Auckland Council consultation

Redvale Landfill Expansion
Responses to Auckland Council Comments
Tranche 1

Table B 1: Response (Andrew Stiles) to Auckland Council (Kyle Li) comments on the Draft Geotechnical Assessment

Table D 1: Responses (Leon Pemberton) to Auckland Council (Stephen Collins – Beca) comments on the Draft Hydrogeological Assessment

Title: Section E2-2025-check.gsz

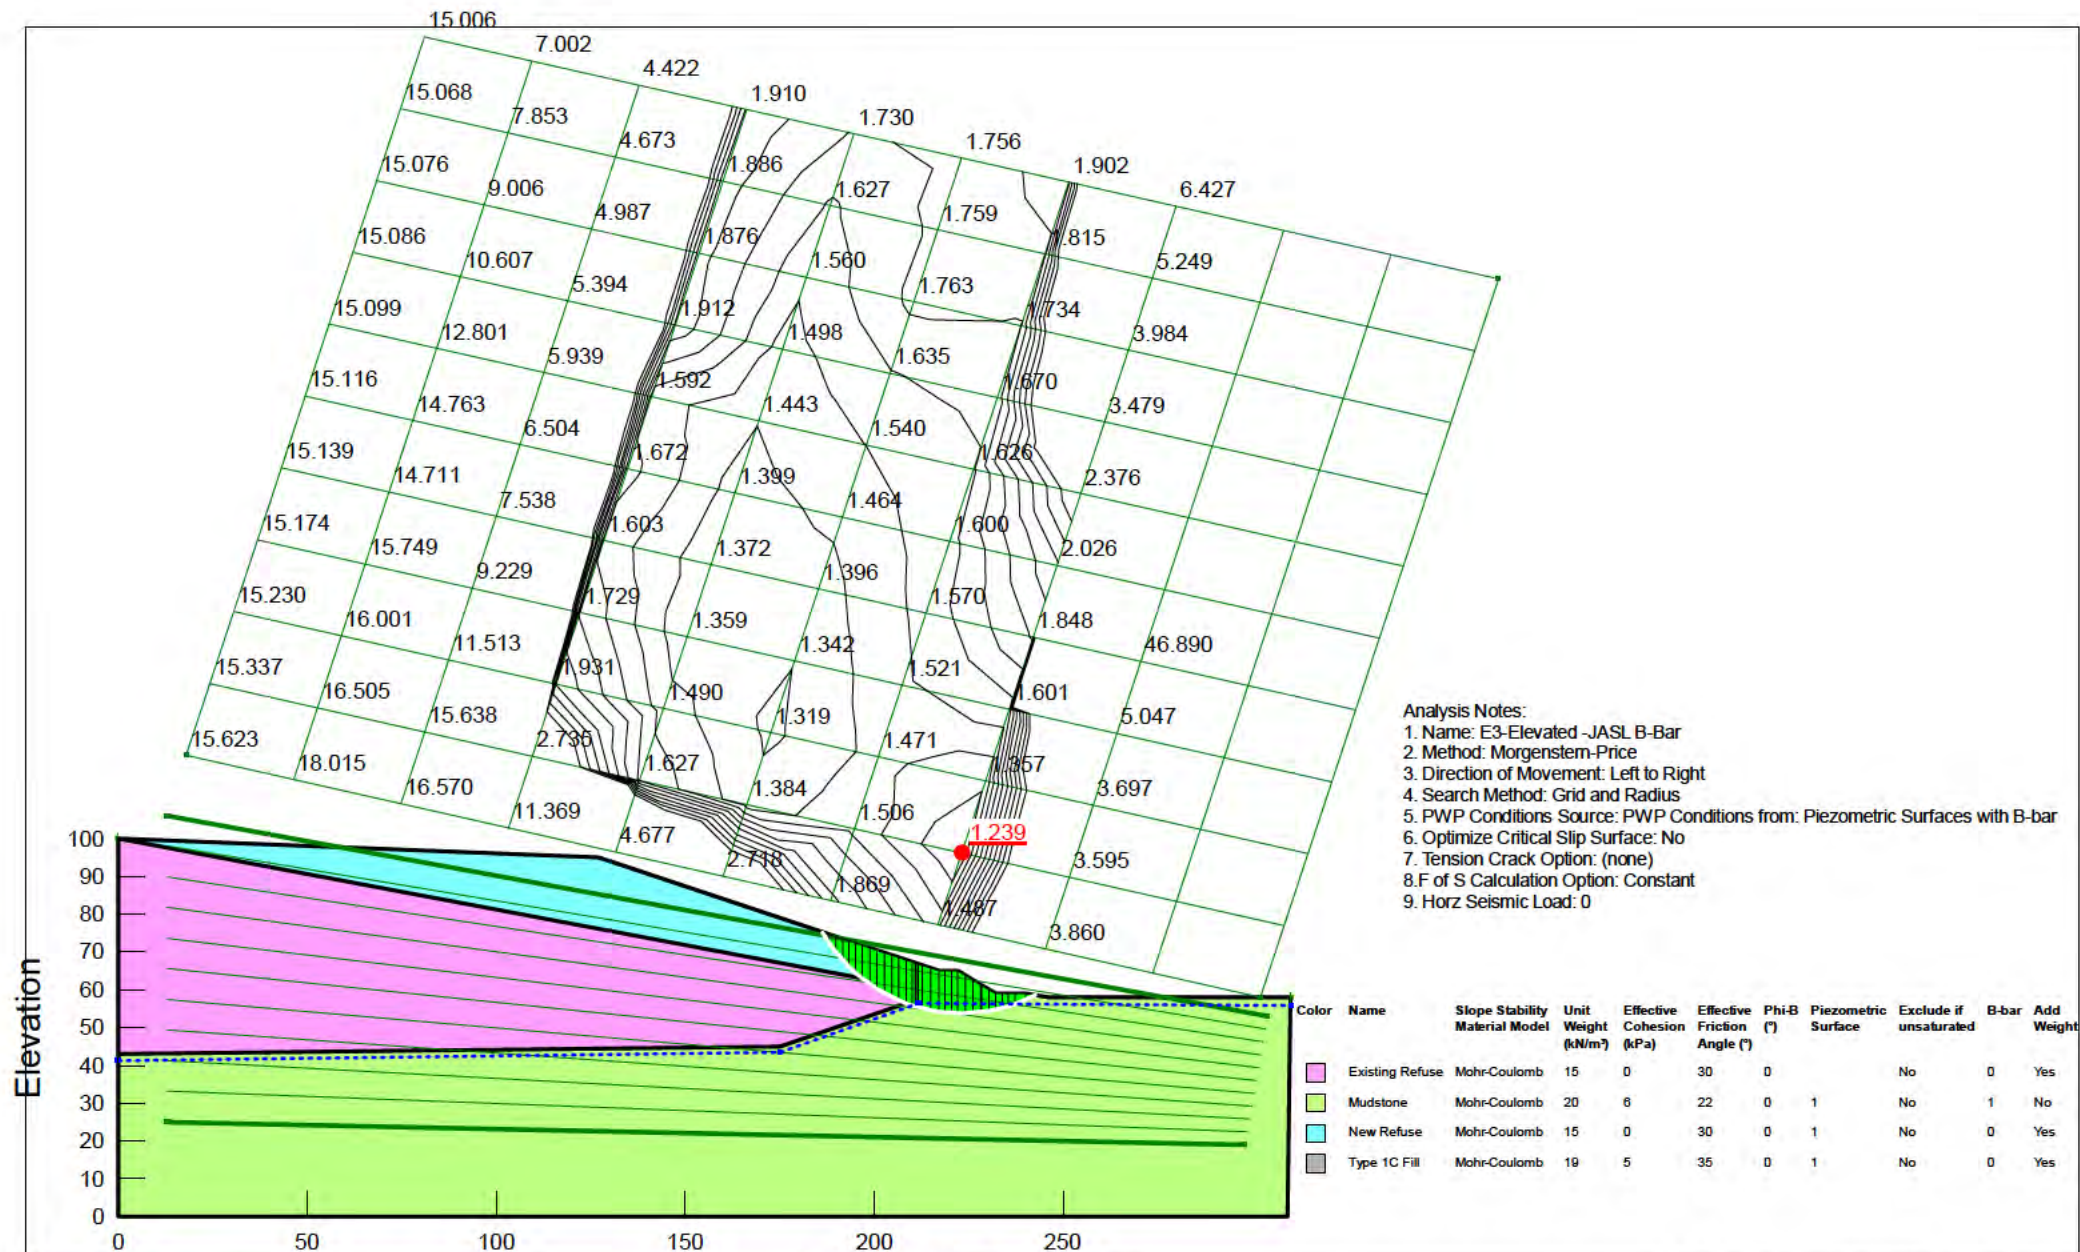
#	Comment	Response												
1	It is noted that the placement of refuse at the site is expected to result in excess pore water pressures being generated within the liner and strata underlying the footprint of the existing landfill. It is also noted that the slope stability analyses, presented within the Draft Tonkin + Taylor Geotechnical Assessment Report, dated March 2026, do not make any allowance for any excess pore water pressures generated from the placement of refuse, i.e. the analyses assumes that any excess pore water pressure will be dissipated instantly, and only the piezometric line is used to determine the pore water pressure within the slope stability analyses. Please provide additional slope stability analyses which consider the effect that the placement of refuse will have on the pore water pressures within the strata underlying the footprint of the existing landfill, i.e. the use of “Piezometric Line with B-bar” analyses within Slope/W. If required, please provide a staging methodology/sequence and associated maximum pore pressures that should not be exceeded beneath the toe bund and landfill during filling and any geotechnical monitoring to be undertaken to measure/monitor pore pressures.	If fill is placed rapidly over low strength, compressible soils then excess pore water pressures can be generated which can affect or reduce the assessed slope stability Factor of Safety (FoS). However, for this project we note that the Landfill has been constructed entirely over unweathered Northland Allochthon Mudstone, Siltstone and Limestone, and Waitemata Group Sandstone, with assessed strengths varying from very weak to moderately strong. All soils, such as Pleistocene Sediments, were removed for the existing landfill prior to any refuse placement, and a similar approach will be adopted for the proposed Class 2 extension works. For the purposes of the Slope/W analyses c' and Φ' drained shear strengths have been assumed, effectively treating the founding subgrade as soils although in practice they are unweathered relatively high strength, low compressibility fractured rock. For waste placed within the landfill, even if it were assumed that placing such waste could potentially induce temporary excess pore water pressures, we consider that there would be negligible adverse effect on slope stability as the waste is totally enclosed within the landfill void. The additional waste to be placed on the (inner) edge of the proposed perimeter bunds, to form the revised (steepened) waste profile could, in theory, induce temporary excess pore water pressures, which could affect the slope stability of the landfill/bund interface. Conservatively, we have assessed the potential for such instability using the “piezometric Line with B-bar” analysis option within Slope/W, as suggested. Analyses were carried out along two representative cross-sections E2 and E3, for the elevated groundwater case, and the Slope/W output plots are attached as Figures Q1-A and Q1-B respectively. The results of the analyses are summarised as:

The analyses show that, as expected from the analysis assumptions, the assessed FoS decrease for B-bar analysis. However, the assessed FoS are greater than the target FoS of >1.1 for elevated groundwater conditions, (see Table 9.1 in the draft Geotechnical Assessment Report). We consider these analyses are conservative for reasons including:	Section	Assessed FoS (No B-bar)	Assessed FoS (B-bar)	Meets target FoS?	E2	2.213	1.177	Yes	E3	1.926	1.239	Yes
Section	Assessed FoS (No B-bar)	Assessed FoS (B-bar)	Meets target FoS?											
E2	2.213	1.177	Yes											
E3	1.926	1.239	Yes

Title: Section S1-2025.gsz

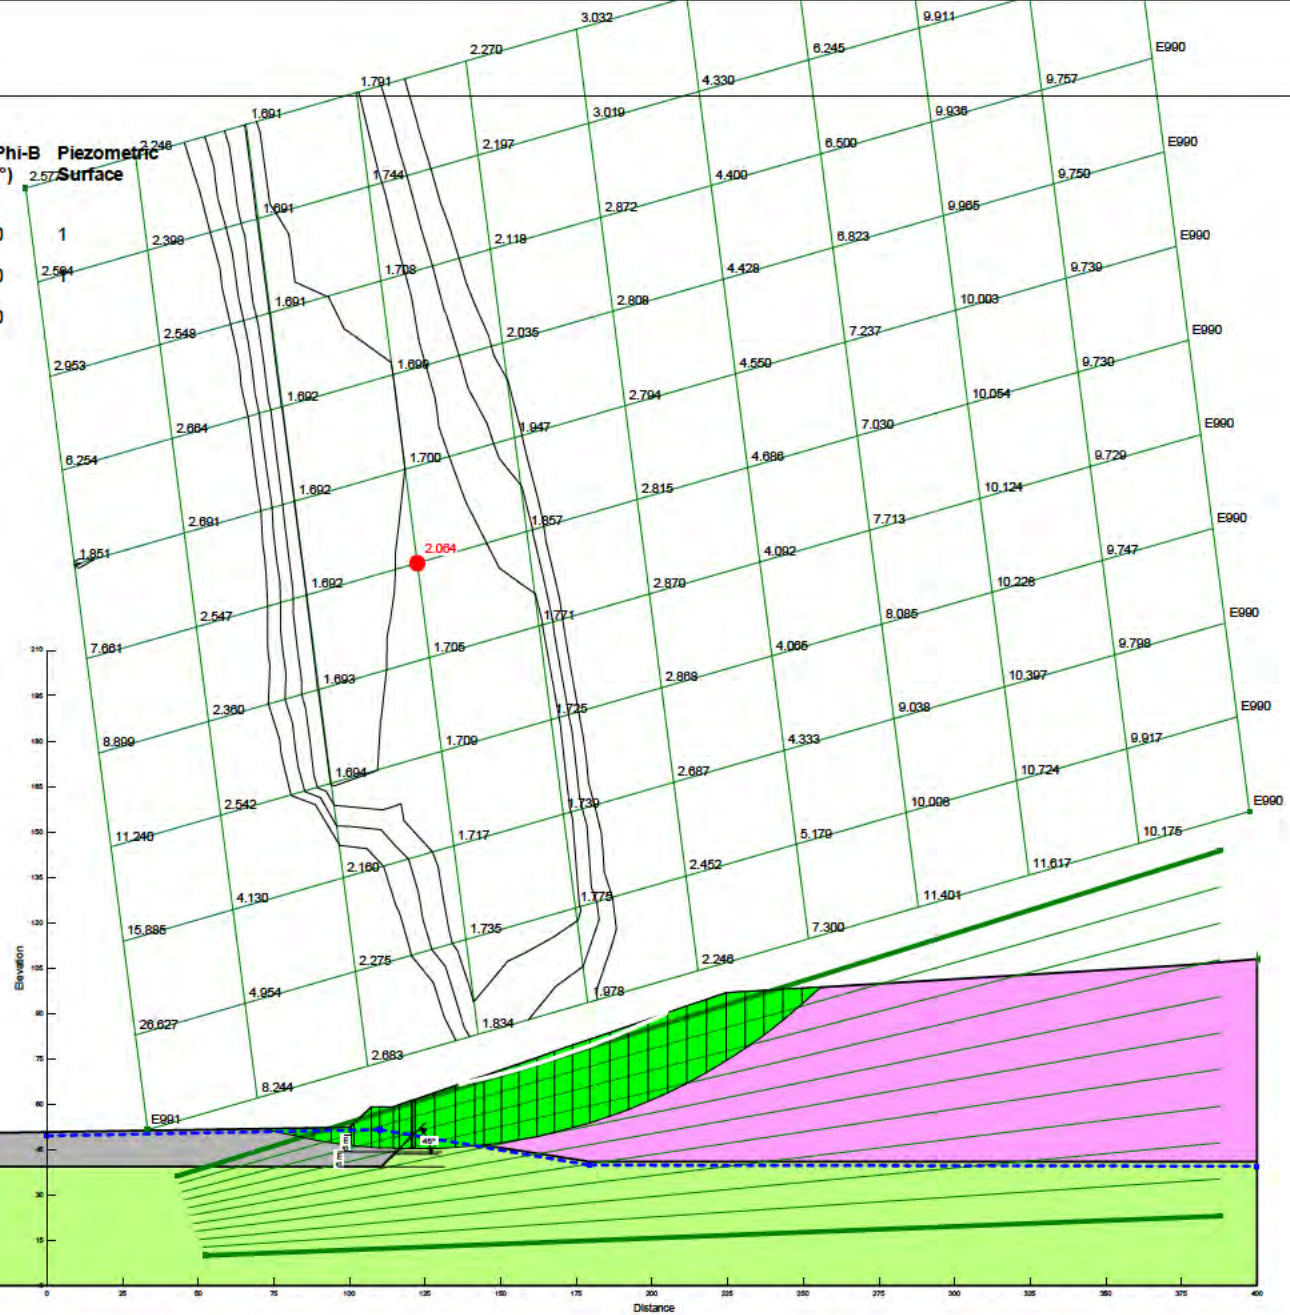
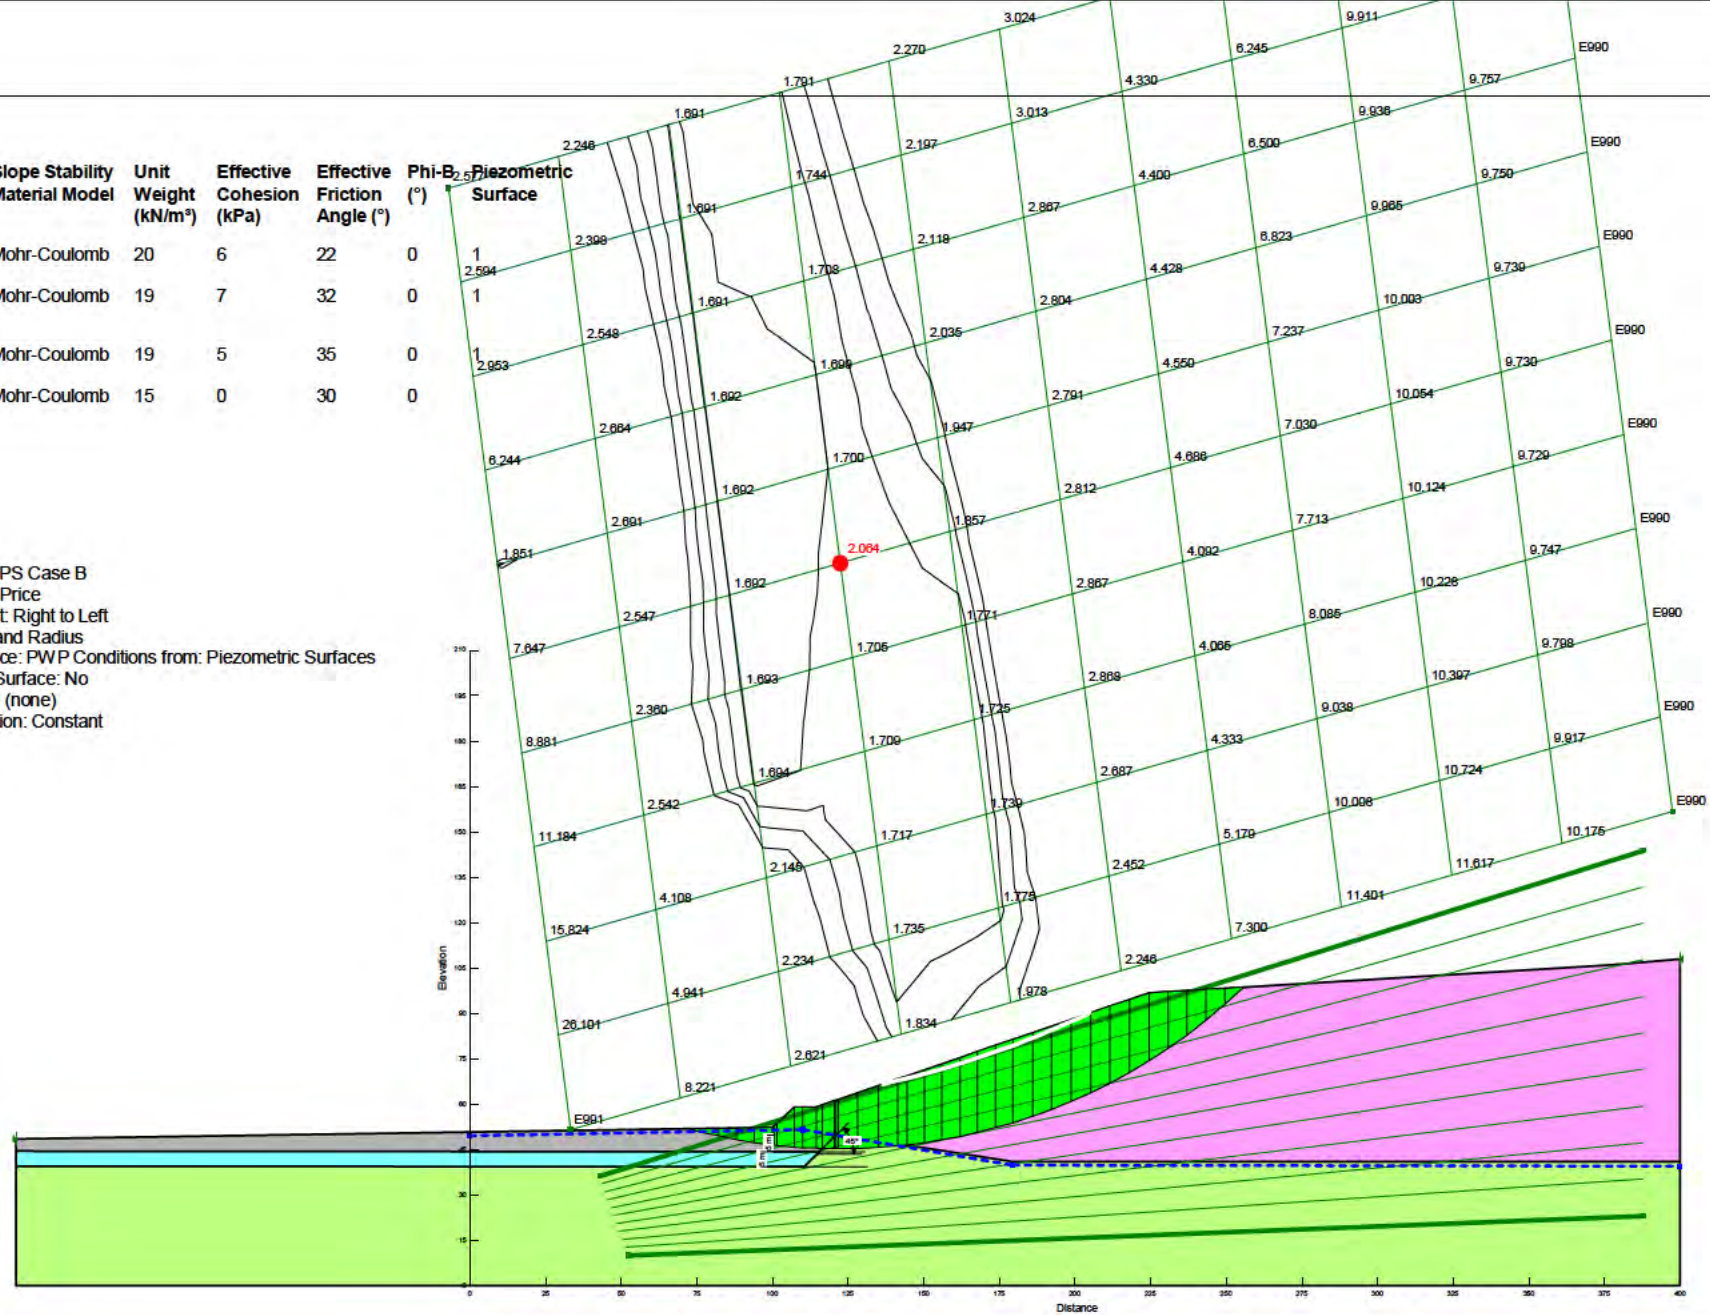
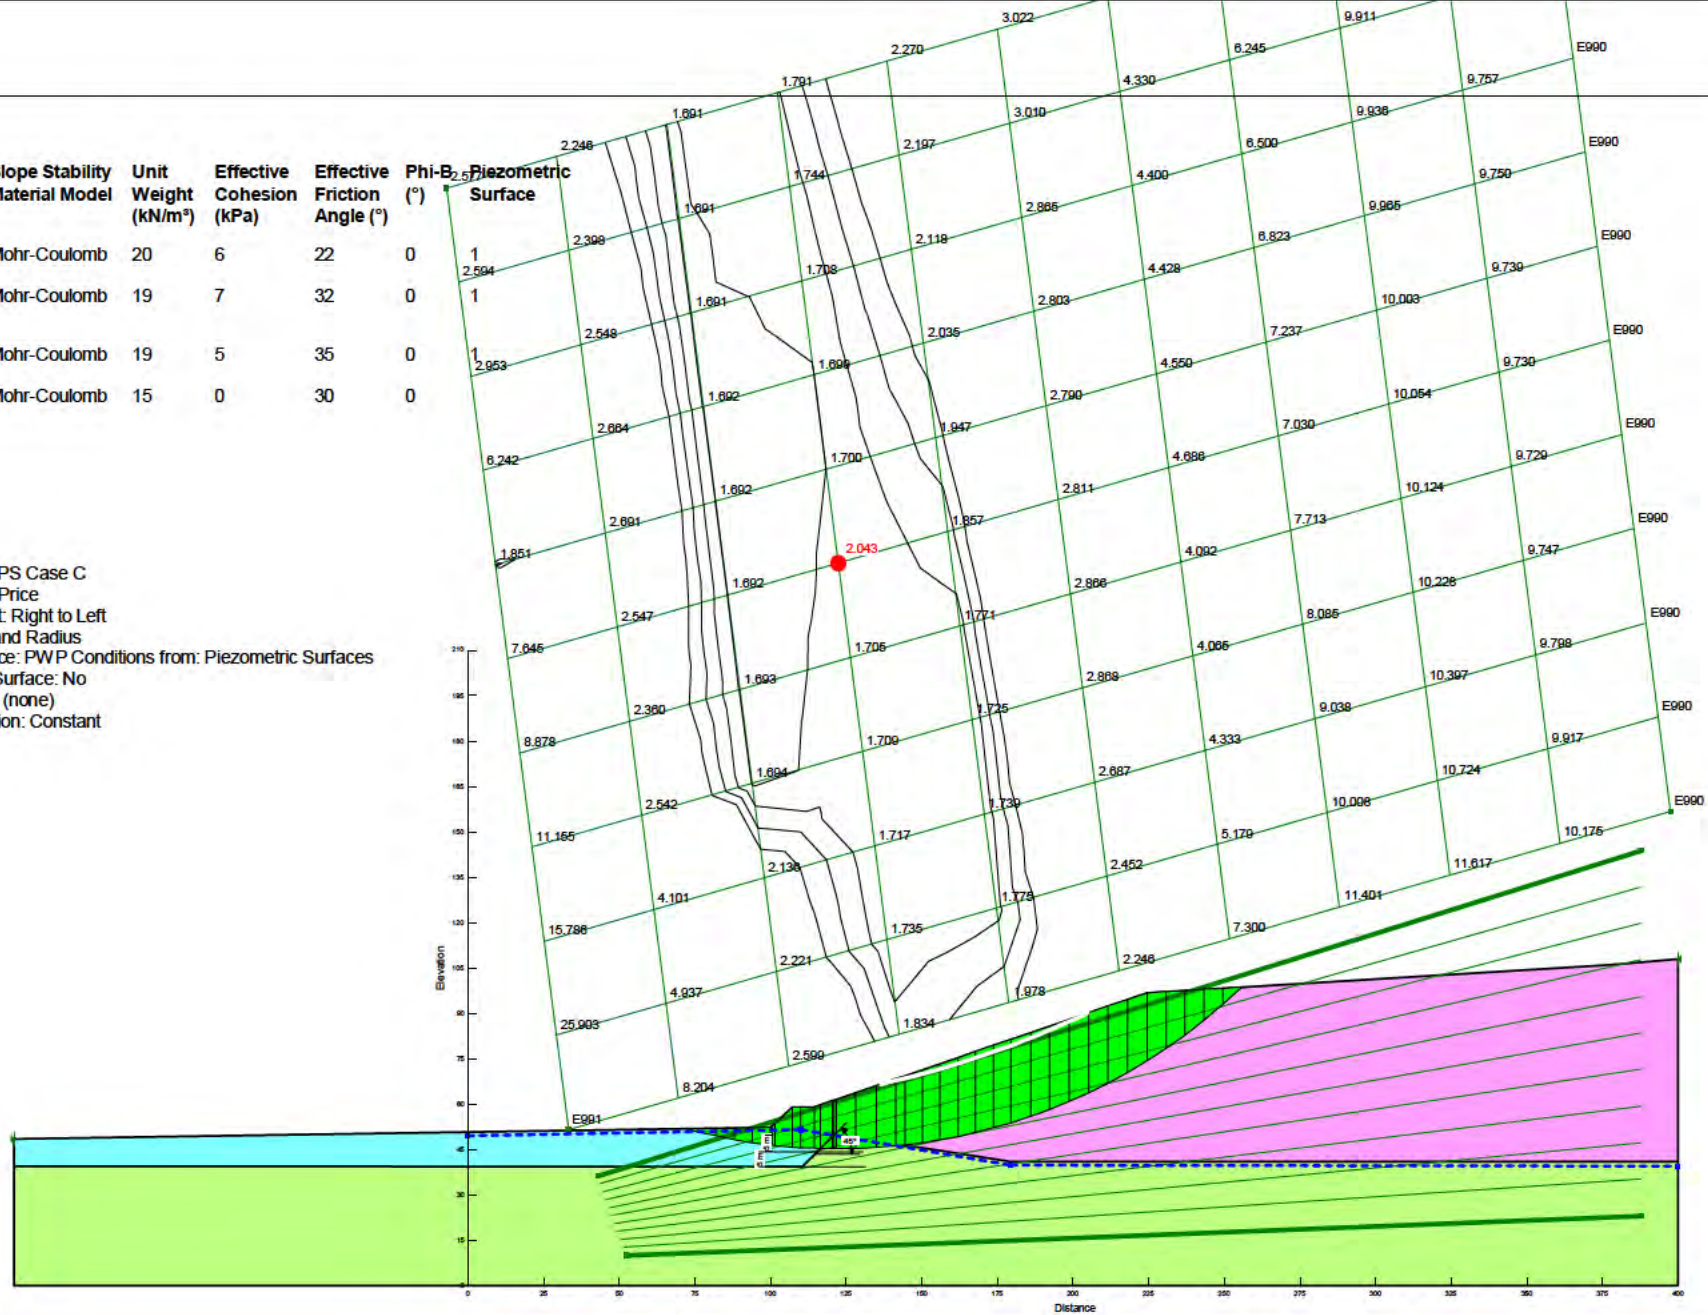
#	Comment	Response												
		- The bunds will be underlain by rock, with any soils having been removed, and that is conservatively modelled in terms of likely pore pressures by the Slope/W analyses. - The loading on the bunds' inner edge from the landfilling will be gradual as waste is progressively placed up to the final profile, likely over a period of years. If any excess pore water pressures were to develop then they will therefore have time to dissipate as the total final loading will not be instantaneous. - As discussed in the draft Geotechnical Assessment Report, 'worst-case' conditions have generally been assumed for the slope stability analyses along the selected cross-sections, assuming low strengths for the Northland Allochthon mudstone and maximum elevated groundwater levels. In practice ground and groundwater conditions are expected to be better than those assumed 'worst-case' design parameters and conditions. - The check B-bar analyses show that the assessed FoS still meet target values, even with the conservative and unlikely assumptions regarding generation of excess pore water pressures. In view of the above, the actual slope stability FoS for the refuse/bund interface will be greater than indicated by the B-bar analysis and likely similar to the higher currently reported (non-B-bar) analysis results. Our overall conclusion is that the generation of excess pore water pressures, which could potentially adversely affect slope stability, is unlikely, and the current Slope/W model assumptions and analyses are appropriate in view of the conservative assumptions. On the basis of the analysis above, a staging methodology/sequence is considered unnecessary.												
2	It is noted that alluvial sediments were encountered adjacent to the southern edge of the 'Eastern Property' to a depth of circa 10.2 m below the existing ground surface (at the location of Borehole MBH12). It is also noted that Cross Section S1, located along the approximate location of Borehole MBH12, indicates that the southern edge/bund of the 'Eastern Property' is underlain by 'Mudstone N7'-type material. Please update the slope stability analyses, at the location of Cross Section S1, to be in accordance with the EGL ground investigation undertaken along the southern edge/bund of the 'Eastern Property'.	Our response to Question 3, below, provides a geotechnical assessment of proposed undercut excavation and replacement options for construction of the perimeter bund in the vicinity of Cross-section S1. That geotechnical assessment identified several possible construction options, to be confirmed as part of detailed design, namely: - Option 1: Assuming a 10 m depth of Pleistocene Sediments, with the upper 5 m replaced by Type 1C engineered fill. - Option 2: Assuming the full 10 m thickness of Pleistocene Sediments is replaced by Type 1C engineered fill. - Option 3: Assume the assessed 10 m depth of Pleistocene Sediments is left in place. Stability analyses have been carried out for the three options, and the Slope/W stability plots are attached as Figures Q2-A, Q2-B and Q2-C. The results of the analyses show:

#	Comment	Response			
		Option 3	2.043	1.812	Yes
		Current design (no undercut)	1.964	1.691	Yes
		Note that for the purposes of this conceptual option assessment, the Pleistocene Sediments and Type 1C fill have been modelled as continuous layers. That is a conservative assumption as the Pleistocene Sediments would have been removed from immediately adjacent to the Landfill cell highwall prior to liner placement and any replacement of Type 1C fill would only extend a finite distance from the southern edge of the perimeter bund. Cross-section S1 was intended as a representative cross-section through the southern boundary, and it is coincidental that MBH12, identifying deep Pleistocene Sediments, lies adjacent to it. The current assessed stability analyses FoS for that general Cross-section S1 is therefore also given in the above Table for comparison. The stability analyses indicate that assessed FoS for the assessed possible construction options comfortably meet the target FoS and are similar to the assessed general cross-section reported FoS.
